REFERENCE  
**XXX-EQCOD-EC-XXXX**

Date: 2017-05-03

## ENGINEERING CHANGE REQUEST

# WP11: Point 2 Connection Cryostat Full Assembly

Figure 1 —Laser scan of area under change, R22 – present LEBR.11L2 (July 2017)

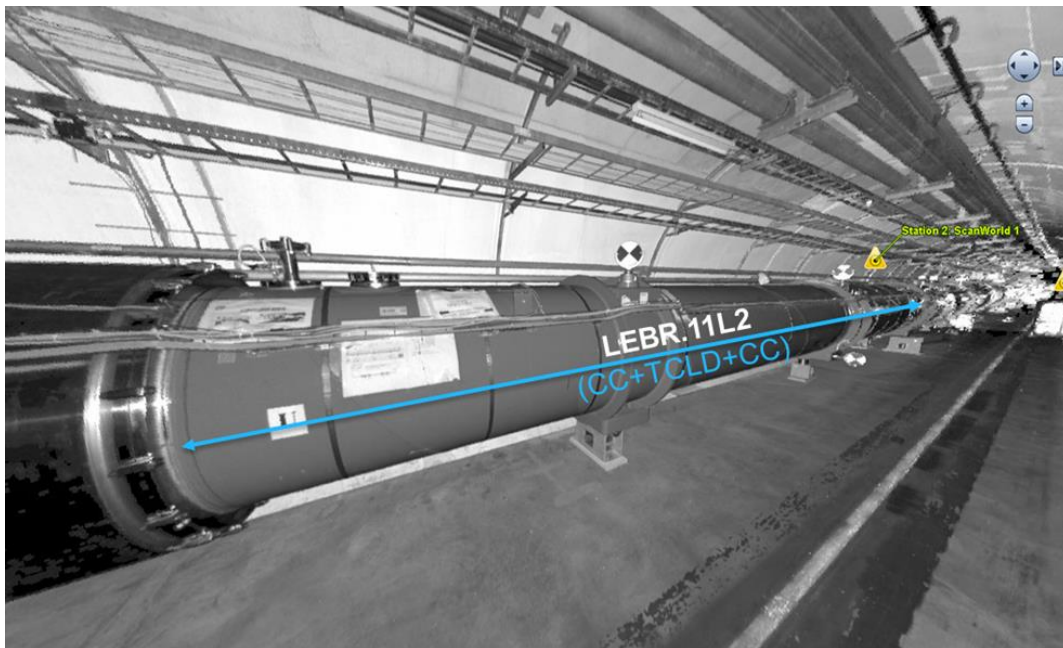
- Removal of the present cryostat **LEBR.11L2**.
- Installation of the connection cryostat full assembly at the LEBR place. The assembly is composed of two new connection cryostats (shorter in length), with a bypass cryostat installed between them.
- After that, installation of a new TCLD collimator between the two connection cryostats, on the beam line 2, **B2I** (internal beam, passage side) will follow.

Figure 2 —Laser scan of area under change, R28 – present LECL.11R2 (July 2017)

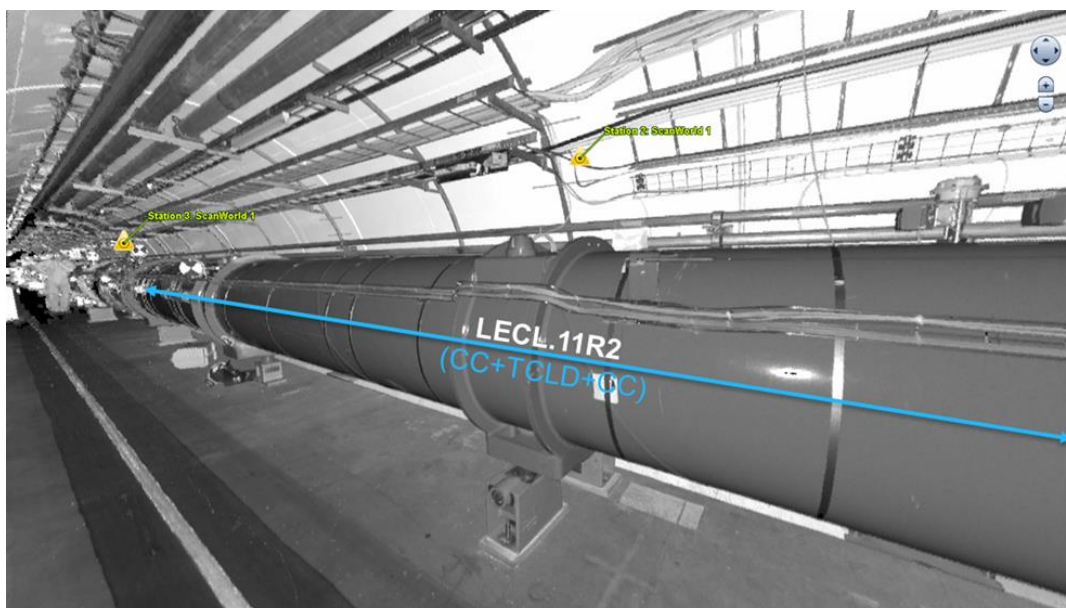
- Removal of the present cryostat **LECL.11R2**.
- Installation of the Connection Cryostat full assembly at the LECL place.
- After that, installation of a new TCLD collimator between the two connection cryostats, on the beam line 1, **B1I** (internal beam, passage side) will follow.

Figure 1: Section of LHC layout for P2 left (from LHCLSS\_000019) – Replaced magnet.

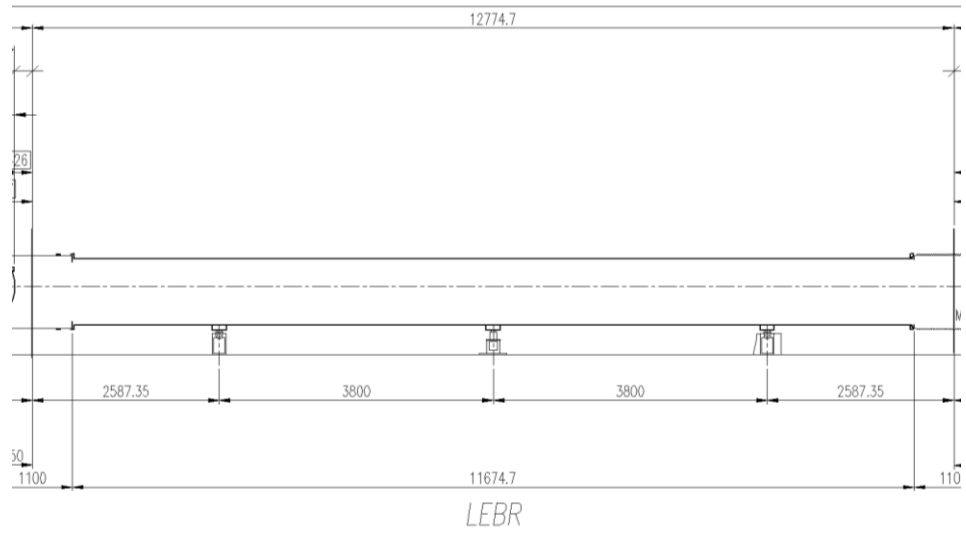
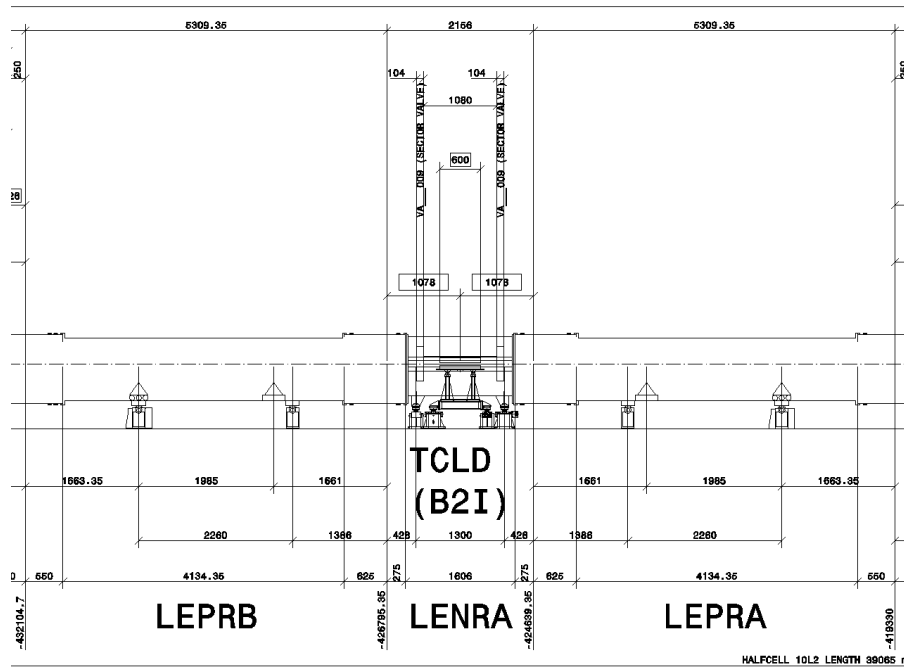
Layout drawings LHCLSS\_\_0019/LHCLSS\_\_0020 (LHC layout for the DS region at point 2) and LHCLSSH\_0003/LHCLSSH\_0004 (HL-LHC layout for the same zones) show the changes induced by the implementation of the TCLD collimator and the two connection cryostats where there was one  $\sim 12$ m long connection cryostat. Figures 3 and 4 show as an example the section of the LHC layout for P2 left before and after the change.
